**ADMINISTRATIVE AMENDMENT**

CITY OF ALBUQUERQUE / FAMILY & COMMUNITY SERVICES  
 SINGING ARROW COMMUNITY CENTER

City Project No. **5441.95** Zone Map No. **L-22-Z** Sheet **AS101** of **85**

**SINGING ARROW COMMUNITY CENTER ENLARGED SITE PLAN**

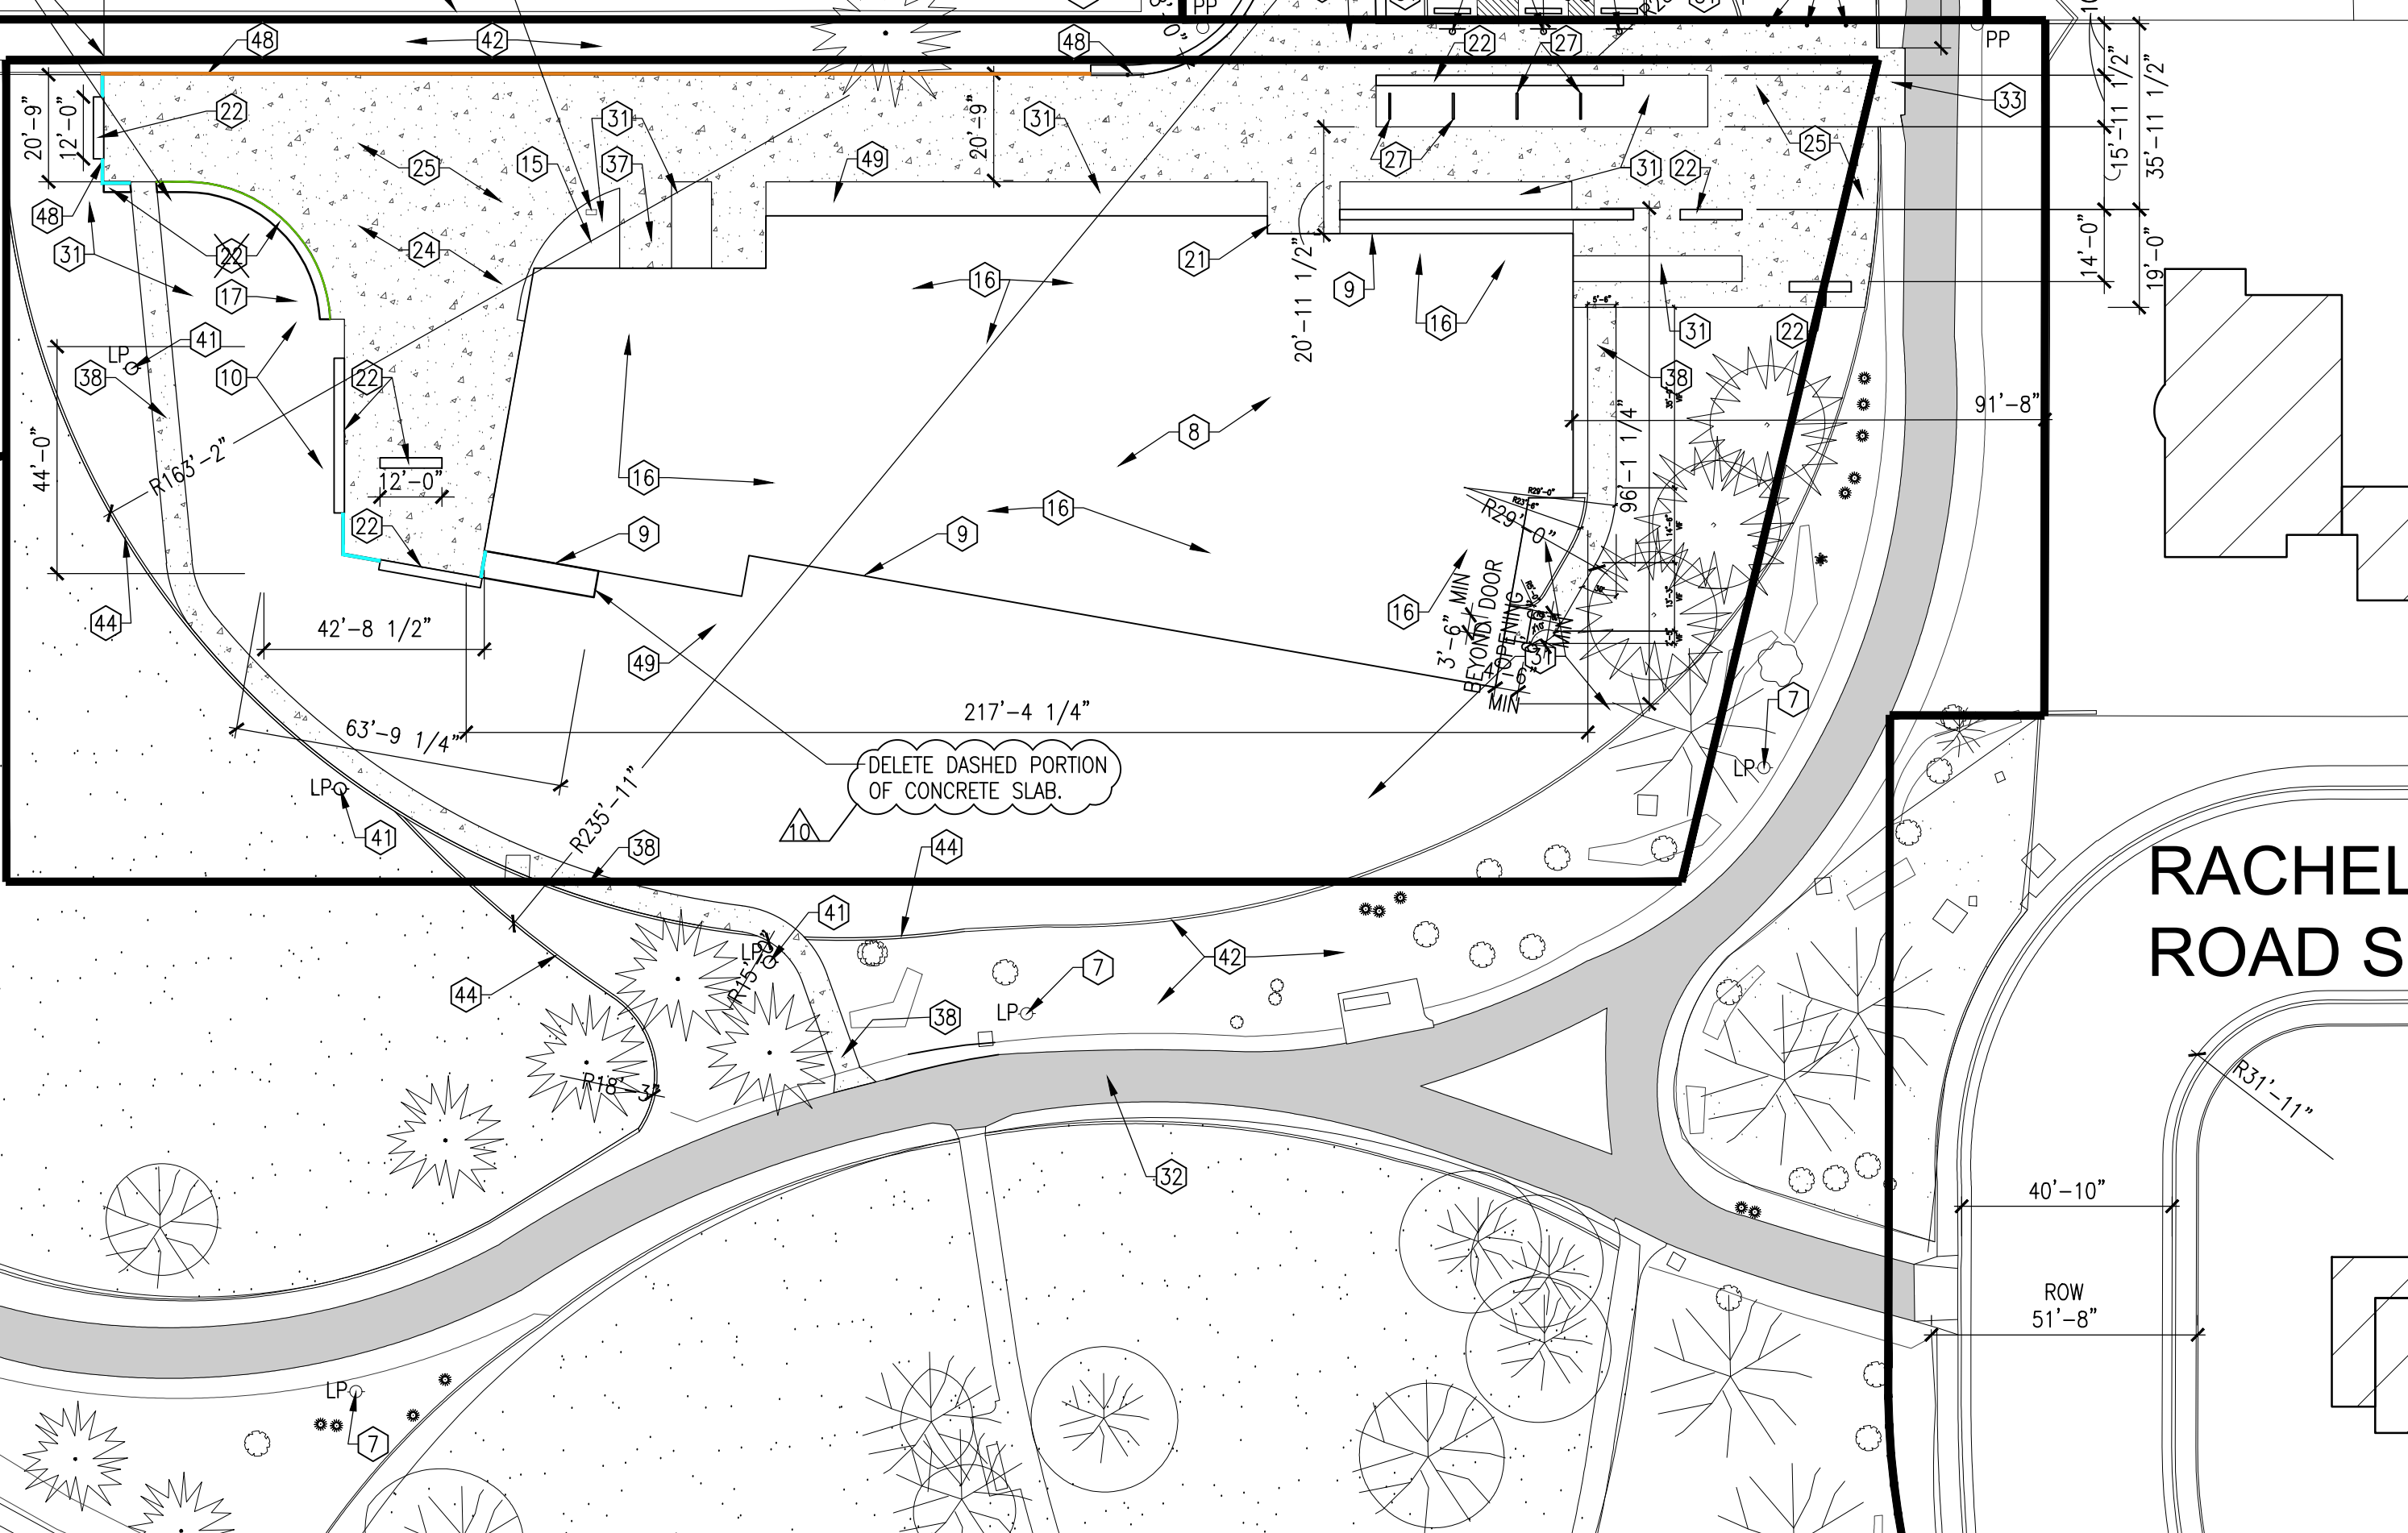
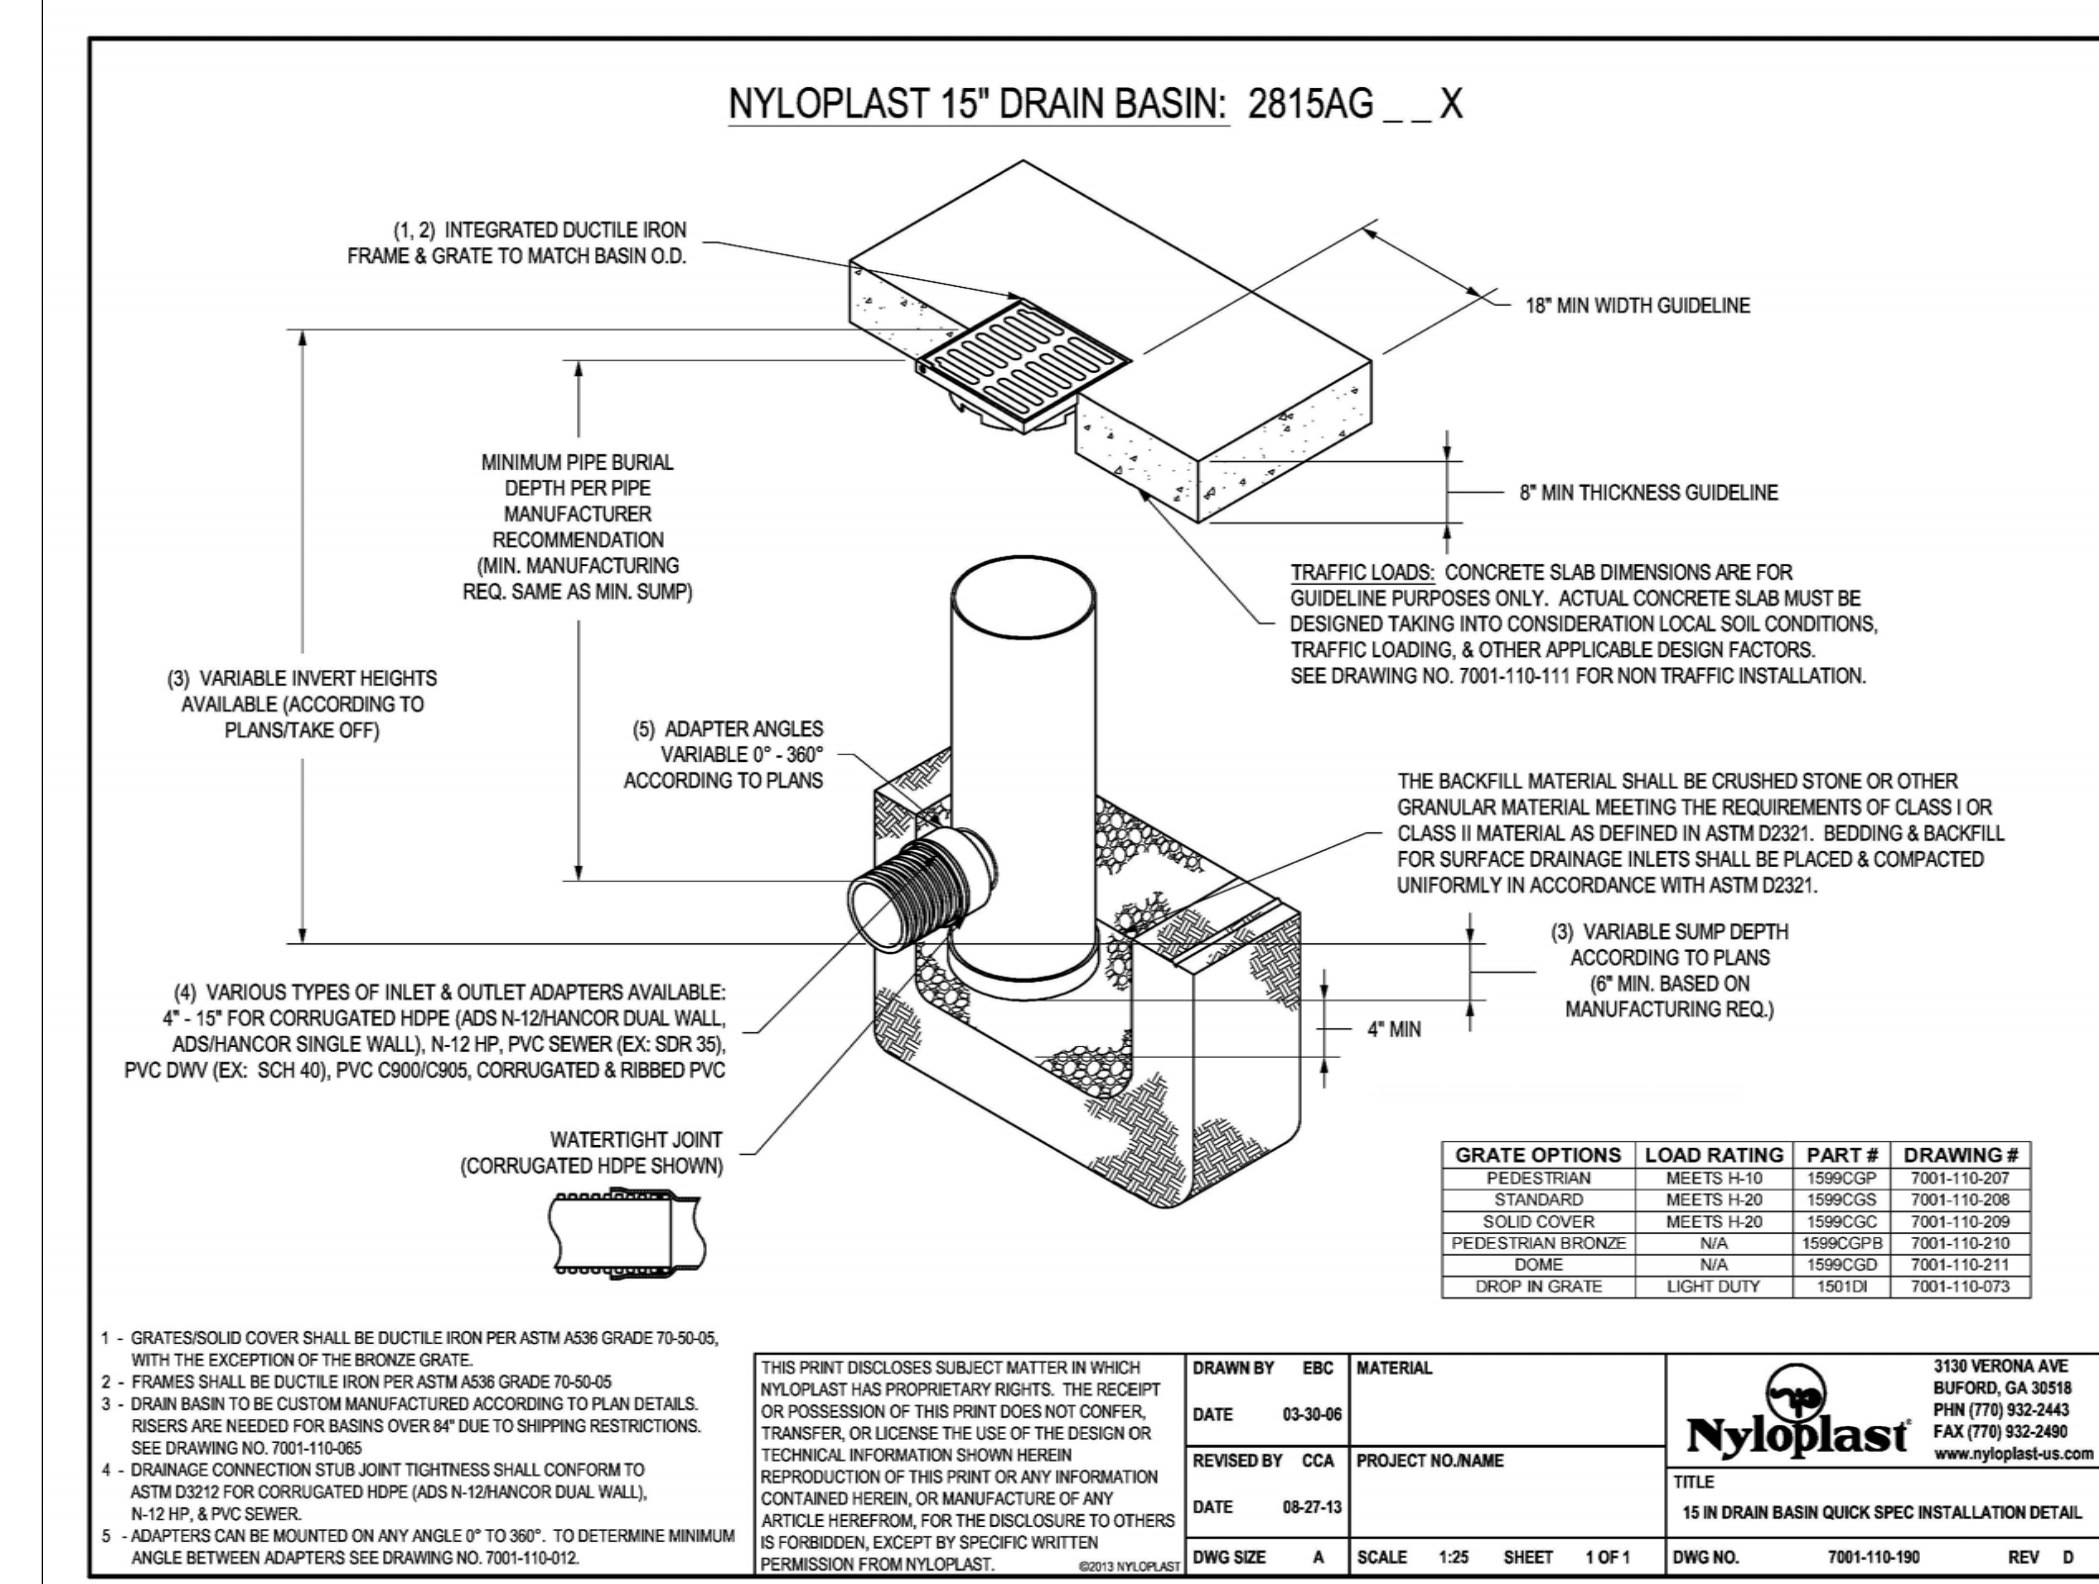
- AT GREEN LINE, PROVIDE TURNDOWN EDGE ONLY PER DETAIL B5/AS501
- AT BLUE LINES, PROVIDE TURNDOWN EDGE PLUS CURB PER DETAIL B5/AS502
- AT ORANGE LINE, PROVIDE MONOLITHIC HEADER CURB PER DETAIL C5/AS502; GRADUALLY STEP DOWN TO NORMAL HEADER CURB HEIGHT.

REMOVE TWO EXISTING TREES TO COMPLETE GRADING

REMOVE GABION BENCHES FROM INDICATED AREAS (50 LF OF GABION BENCHES REMOVED). RELOCATE GABION BENCHES AT SOUTH AND WEST SIDES OF CONCRETE (50 LF OF GABION BENCHES RELOCATED)
